Device TC1796
Marking/Step EES-BC, ES-BC, BC
Package P-BGA-416, PG-BGA-416

02131AERRA

This Errata Sheet describes the deviations from the current user documentation.

Figure 3 Timing concerning equidistant multiple timers

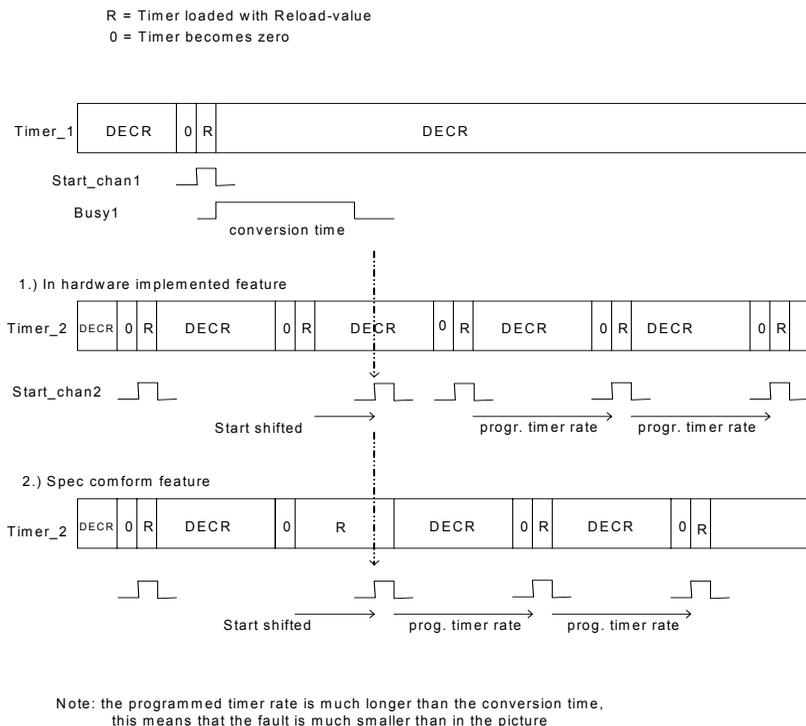
The correct behavior would be a reload when the requested conversion (of channel_2) is started.

Therefore the start of conversion for channel_2 is delayed by maximum one conversion-time. After this delay it will be continued with equidistant conversion-starts. Please refer to the following figure.

FADC_TC.008 V_{FAREF} reliability issue

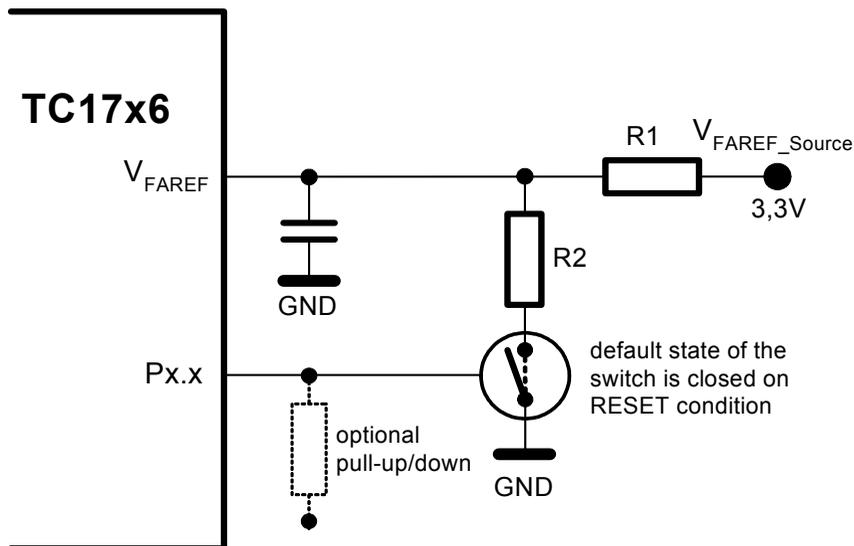
The V_{FAREF} voltage is directly connected via an resistor to the gate of an 1.5 V transistor if the analog part of the FADC is not enabled by setting bit GCR.ANON in the FADC.

For V_{FAREF} voltages above 1.65 V this can cause oxide damage in the gate of an 1.5 V transistor which may lead to an increased leakage current at the V_{FAREF} input pin.

Figure 8 FIFO structure

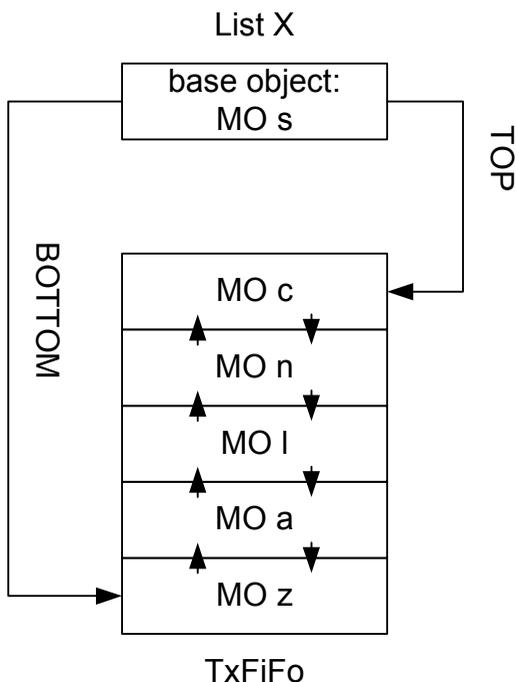
If Tx FIFO overflow interrupt needed, take the FIFO base object out of the circular list of the Tx message objects. That is to say, just use the FIFO base object for FIFO control, but not to store a Tx message.

Table 13

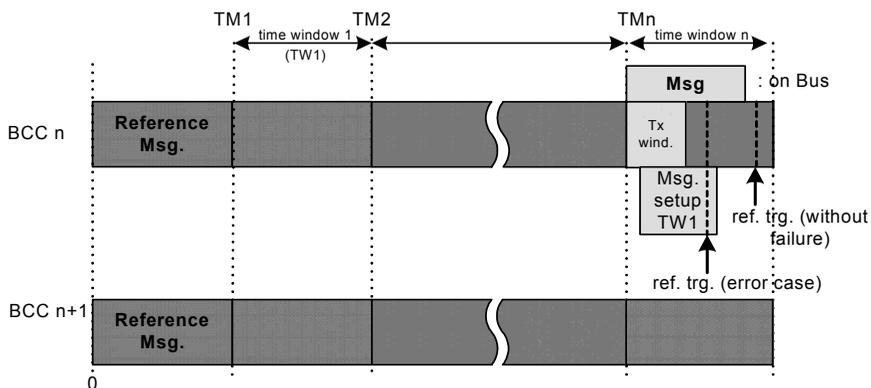
When the modes 001_B-100_B are set in register $NFCR_x.CFSEL$, the actual configured mode and behaviour is different than expected.

Bit timing mode (NFCR.CFSEL) according to spec	Value to be written to NFCR.CFSEL instead	Measurement
001 _B	Mode is missing (not implemented) in MultiCAN	Whenever a recessive edge (transition from 0 to 1) is monitored on the receive input the time (measured in clock cycles) between this edge and the most recent dominant edge is stored in CFC.
010 _B	011 _B	Whenever a dominant edge is received as a result of a transmitted dominant edge the time (clock cycles) between both edges is stored in CFC.
011 _B	100 _B	Whenever a recessive edge is received as a result of a transmitted recessive edge the time (clock cycles) between both edges is stored in CFC.
100 _B	001 _B	Whenever a dominant edge that qualifies for synchronization is monitored on the receive input the time (measured in clock cycles) between this edge and the most recent sample point is stored in CFC.

Figure 13 Short term PLL Jitter in f_{CPU} clock periods at $f_{\text{CPU}} = 150 \text{ MHz}$ and $K = 4$

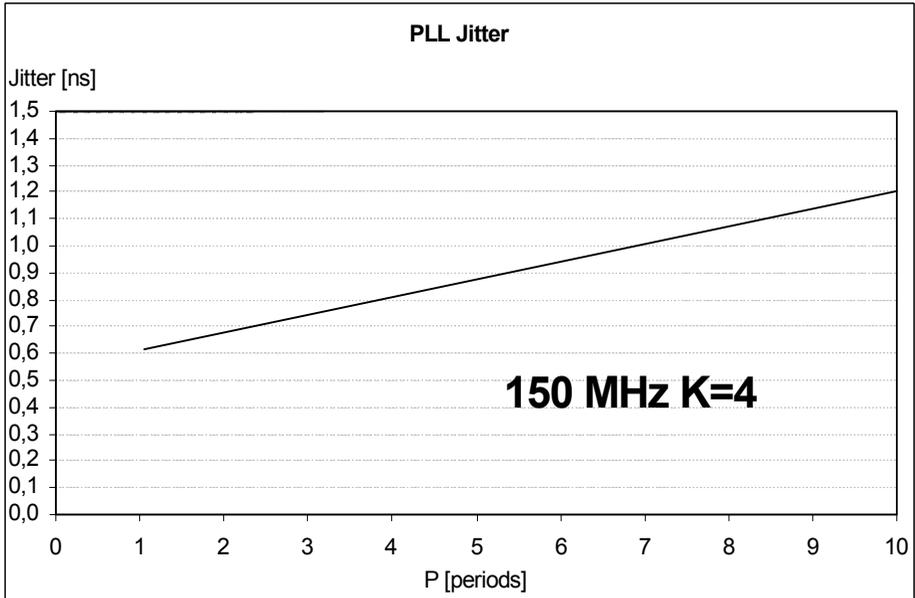
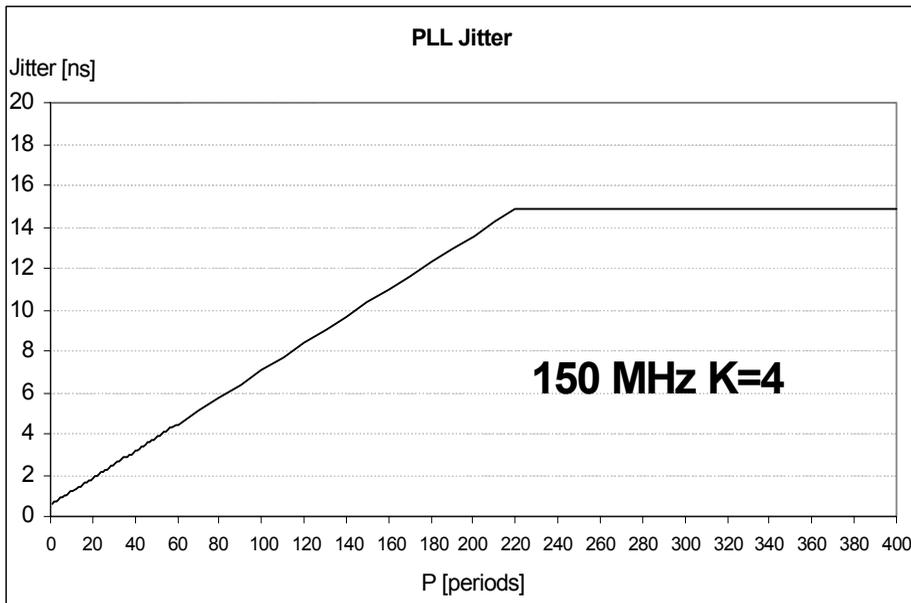
When all listed system preconditions are fulfilled the PLL jitter at 150MHz and $K = 4$ with $K = KDIV + 1$ is below the marked range as shown in the figures.

Figure 15 Exemplary power-up/down sequence

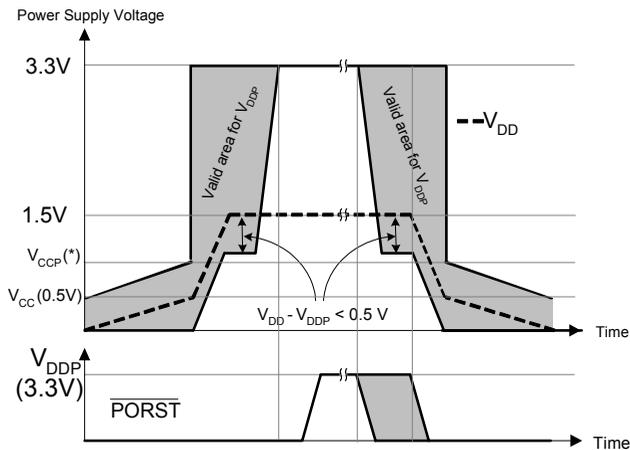
As per Data Sheet, $V_{DD} - V_{DDP} < 0.5\text{ V}$ has to be valid at any time in order to avoid increased latch-up risk. The figure below shows the possible V_{DDP} values as shaded region for an exemplary V_{DD} ramp. Moreover, the following rules apply:

- V_{DDEBU} and all analog voltages (V_{DDOSC3} , V_{DDM} , V_{DDMF} , V_{DDFL3}) must also follow V_{DDP} power-up/down sequence.
- V_{DDAF} , V_{DDOSC} must follow V_{DD} power-up/down sequence.
- The absolute value of the maximum allowed deviation between any two supplies is 0.5 V while the 1.5V supplies are below their specified operating conditions.

Note: V_{CC} and V_{CCP} in Figure 15 refer to devices with PWR_TC.P009 erratum.

Figure 18

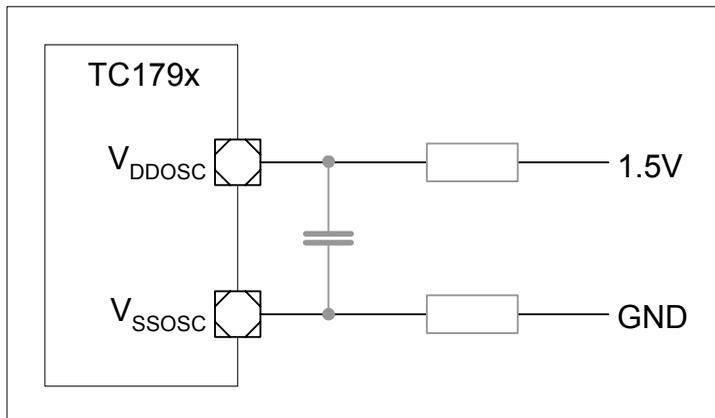
PLL_TC.H004 V_{DDOSC} and V_{SSOSC} bonding change

V_{DDOSC} and V_{SSOSC} silicon pads are not connected to their package balls, but V_{DDOSC} is connected to V_{DD} (core supply) and V_{SSOSC} is connected to V_{SS} , in order to reduce short-term jitter. Thus V_{DDOSC} and V_{SSOSC} package balls are unconnected. For future design improvements it is recommended to prepare the PCB like it is shown in the figure below. The capacitance and both resistors need not to be assembled on the PCB but they should be planned for values of about 10?F...100?F for the blocking capacitance and 0?...10? for the resistors.

Figure 19 Stand-by current at 125°C ambient

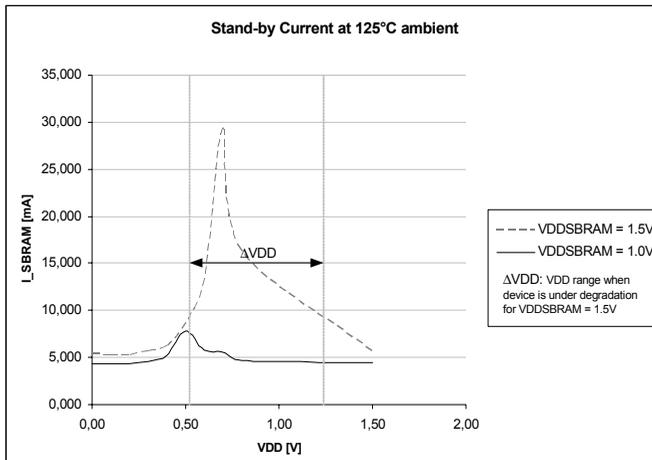
During transition from/to stand-by mode, while increasing or decreasing core power supply (V_{DD}), it may happen, due to cross-current, that I_{SBRAM} reaches high current values.

The worst case takes place when $V_{DD} = V_{DDSB RAM}/2$, specially if $V_{DDSB RAM} = 1.5$ V (SBRAM power supply for normal operation). In this situation, I_{SBRAM} may reach 29.5 mA (hot at 125°C ambient).
